CITY OF ALBUQUERQUE

RE: **Lots 44A and 42A, Oxbow Bluff
Grading Plan
Engineer's Stamp Date 3/29/18
Hydrology File: G11D014G**

**LOTS 44-A AND 42-A
OXBOW BLUFF SUBDIVISION
GRADING PLAN**

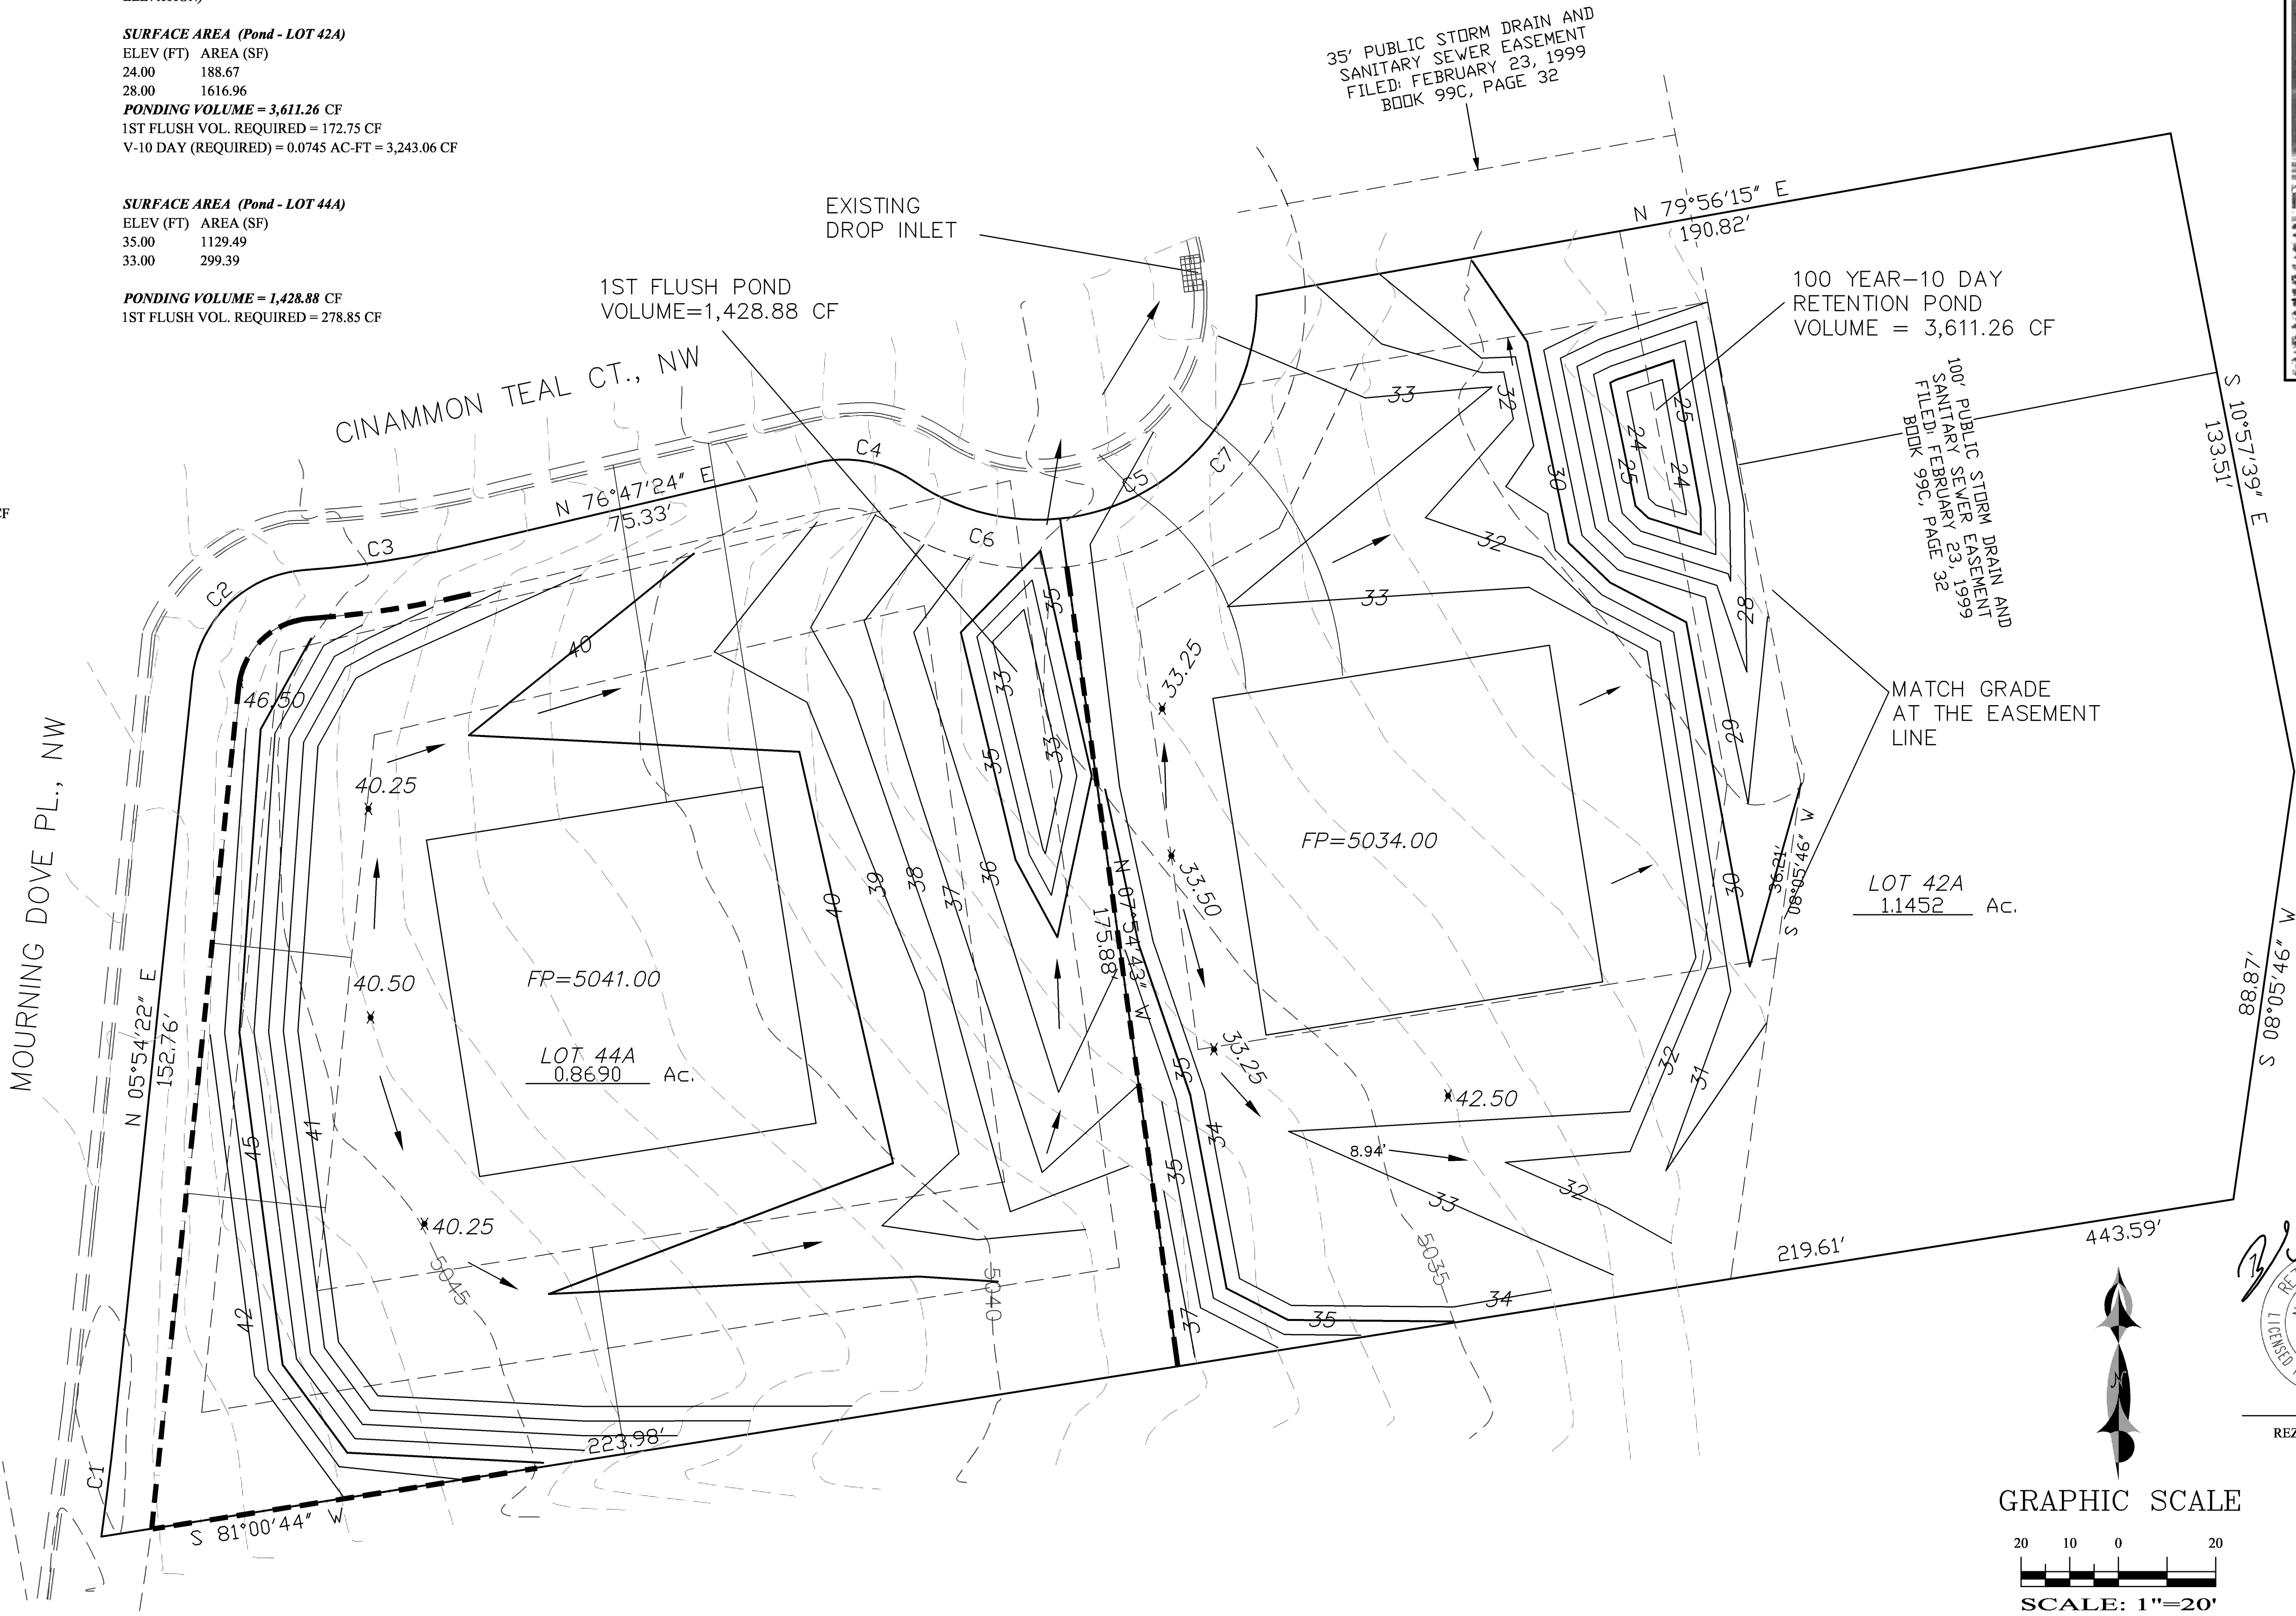
Based on the information provided in your submittal received 4/2/18, the Grading Plan is approved for Grading Permit and Preliminary Plat.

1. The site will need to be graded and Pad Certifications will be required prior to Hydrology approving the residential Building Permits and final sign-off of the Final Plat.

2. Engineer's Certification, per the DPM Checklist, will be required to ensure the ponds and grades remained intact following home construction.
